# Mobile Intel® Celeron® Processor on .13 Micron Process in Micro- FCPGA Package

Specification Update

*September 2004*

Document Number: [251309-022](#)

**Figure 12. System Bus Reset and Configuration Timings**

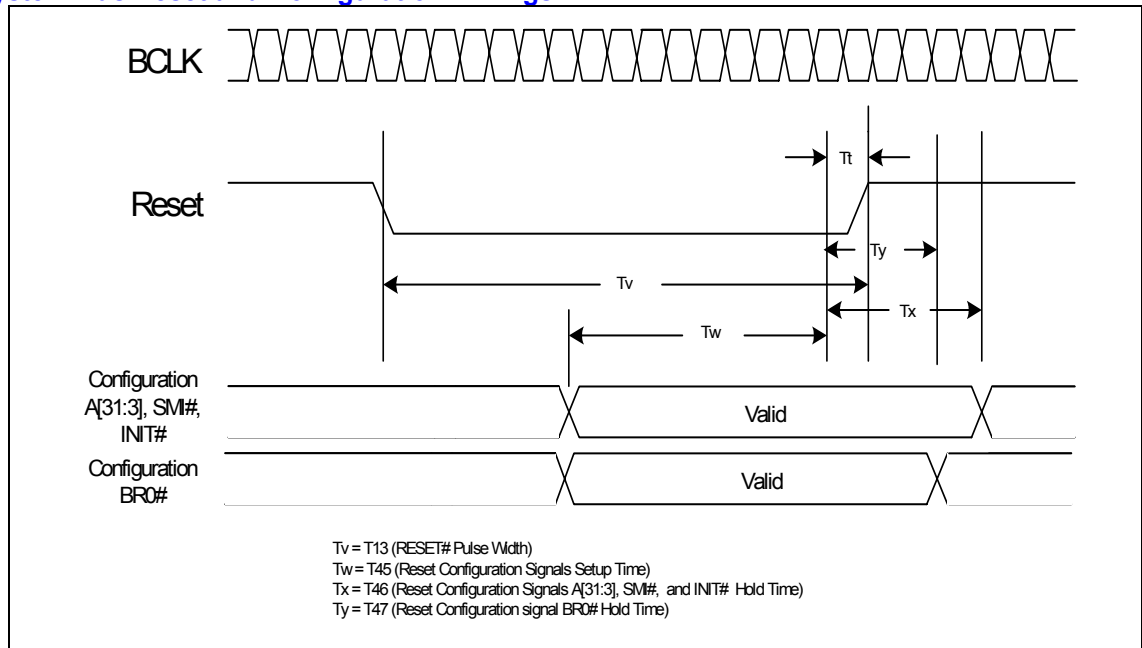
## 2. BR0# Maximum Hold Time Specification Change

The BR0# maximum hold time has changed to 2 BCLKs. This change will be shown in the “System Bus AC Specifications (Reset Conditions)” table and “System Bus Reset and Configuration Timings” figure of the *Mobile Intel® Celeron® Processor on .13 Micron Process in Micro-FCPGA Package Datasheet*. This change will be incorporated in the next revision of the datasheet.

The following figure is modified to reflect this change:

T# Parameter	Min	Max	Unit	Figure	Notes
T45: Reset Configuration Signals (A[31:3]#, BR0# INIT#, SMI#) Setup Time	4		BCLKs	13	1
T46: Reset Configuration Signals (A[31:3]#, INIT#, SMI#) Hold Time	2	20	BCLKs	13	2
T47: Reset Configuration Signal BR0# Hold Time	2	2	BCLKs	13	2
